Reference: Pennsylvania State University Breazeale Nuclear Reactor  
Docket No. 50-005, License No. R-2  
USNRC Request for Additional Information (RAI) dated July 28, 2009

Subject: Response to RAI dated July 28, 2009

## PSBR response to NRC RAI

Figure 2-1: Standard Pulse Radial Temperature Distribution in a Fuel Rod (General Atomics E-117-393)

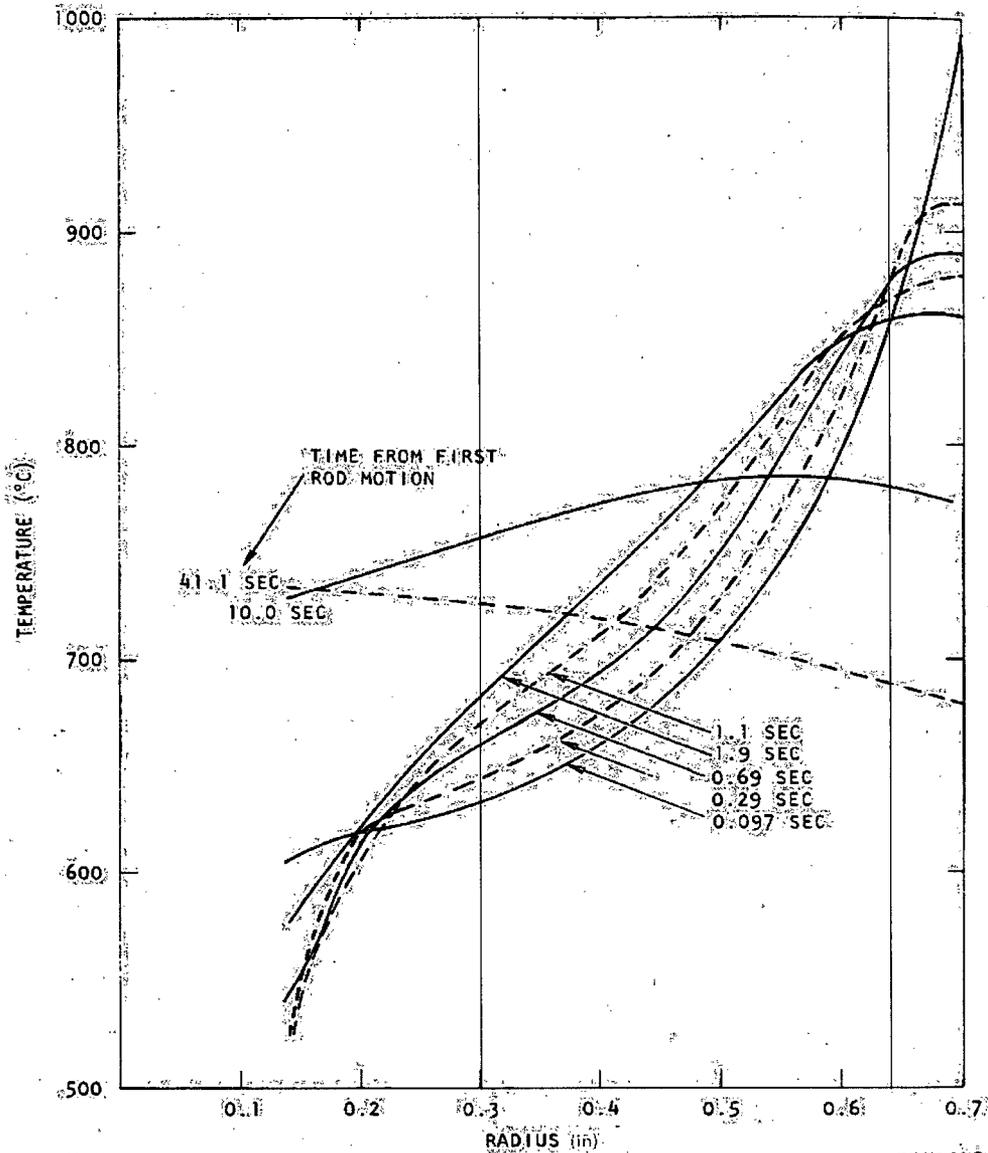
**Explain any uncertainties in the calculation and measurement of the maximum pulse fuel temperature. Explain how the uncertainties are treated to ensure that the maximum pulse fuel temperature will not exceed the safety limit for any core configuration allowed by the TS.**

In 1975, GA published information on TRIGA performance that included temperature predictions and profiles for 12 wt% elements at the Sandia ACPR (E-117-393 Fuel Elements for Pulsed TRIGA Reactor dated 1975). Figure 2-1 shows the calculated temperature distribution of the highest power new 12 wt% TRIGA fuel element during a \$4.80 pulse calculated for the Sandia ACPR (20,000 MW pulse peak power). The highest ratio of the maximum temperature anywhere in the fuel to the temperature at the thermocouple location is 1.57:1 and occurs immediately with the pulse. The PSBR SAR assumption of 1.6:1 bounds the GA analysis. Note the maximum predicted temperature anywhere in the hot element is ~1000 °C.

One of the principal reasons the PSBR SAR is so conservative is the SAR uses the peak measured fuel temperature at the thermocouple location to calculate the maximum peak temperature. In earlier GA work, it was concluded that the time response was sufficiently fast (SAR Chapter 13 Reference 25 – GA-6216 1965) to measure the peak temperature at the thermocouple following pulsing. Levine's work concluded the same. However, unlike 8 wt% fuel where there is little change in the thermocouple location temperature for seconds after the pulse the temperature in a 12 wt% at the thermocouple rises significantly for ~10 seconds after the pulse as conduction equalizes the element temperature (see Figure 14 GA-6216 which is on page 24 of 40 in the October 31, 2008 RAI response and Figure 2-1 below). Since the SAR applies the 1.6:1 ratio to the peak measured value (not temperature at the thermocouple during the maximum temperature profile), the predicted maximum fuel temperatures in the SAR are conservative.

From Figure 2-1, the ratio of the maximum fuel temperature (at ~.1 second) to peak measured (at ~10 seconds) is ~1.3:1, not 1.6:1. Applying the 1.6 ratio to a peak measured temperature in 12 wt% fuel inserts conservancy of  $1.6/1.3 = 23\%$ .

## Figure 4-1: Phases of Zirconium-Hydride as a Function of Temperature

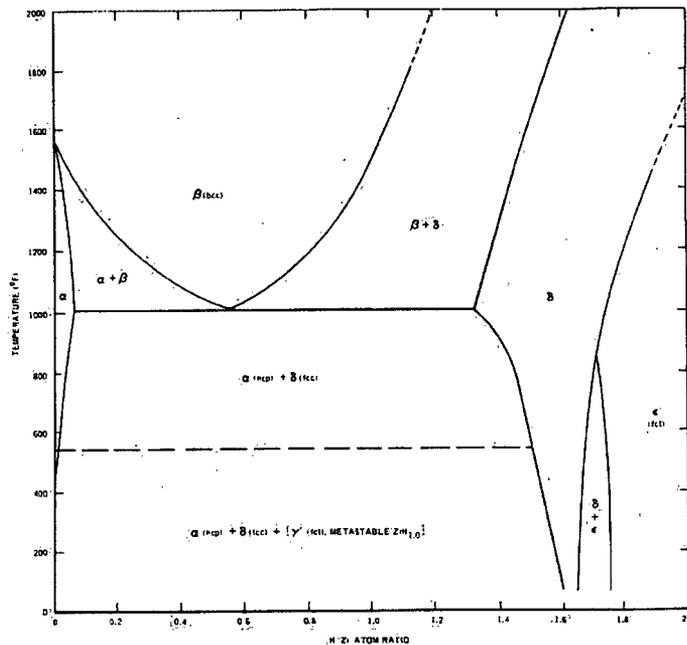
4. TS 5.1.b requires that the hydrogen-to-zirconium atom ratio shall be a nominal 1.65 hydrogen atoms to 1.0 zirconium atoms. Section 4.2.1 of the safety analysis report states that this ratio is 1.7 to 1.0 for 8.5 weight percent fuel elements.

a. Clarify this apparent discrepancy.

The optimal ratio of H/Zr has been refined by new research results since the inception of the TRIGA reactor design. TS 5.1.b states that the nominal ratio shall be 1.65. Nominal is interpreted to be a both target value for fuel fabrication and a value representative of previously procured fuel in use. In 1980 General Atomics revised their specifications for TRIGA fuel H/Zr ratio to a nominal value of 1.6:1 with a maximum of 1.65:1 for both 8.5 and 12.0 wt%<sup>6</sup> (page 4-1). The original loading of 8.5 wt% fuel at Penn State had a nominal value of 1.68 with a maximum of 1.70<sup>7</sup>. The fuel-follower control rods had ratios of 1.72, 1.75 and 1.76, but an explanation for this difference can no longer be located. The documented range of H/Zr in PSU fuel is 1.57 to 1.76.

TRIGA fuel was originally constructed with aluminum cladding, 8 wt% uranium and hydrogen to zirconium ratio of 1:1 on an atomic basis<sup>1</sup>. The change to stainless steel cladding and the higher hydrogen ratio made the fuel more reliable and robust. Once the hydride concentration gets above 1.5, the fuel is no longer subject to thermal phase separation or the thermal cycling effects that cause hydrogen migration in the earlier fuels<sup>6</sup> (page 2-14/2-16). The nominal H/Zr ratio was stated as 1.6:1<sup>6</sup> (page 1-1). Figure 4-1 shows the phase diagram for H/Zr. For any ratio  $\geq 1.65$ , the fuel stays in the delta or epsilon phase for all temperatures below the safety limit (1150°)<sup>6</sup> (Fig 2.4). The presence of uranium in the matrix drops the transition temperatures slightly<sup>6</sup> (page2-5).

The safety limit for TRIGA fuel with a stainless steel cladding and a H/Zr ratio of 1.65:1 is listed as 1150°C under all conditions when the cladding temperature is  $\leq 500^{\circ}\text{C}$ <sup>6</sup> (page 4-1).
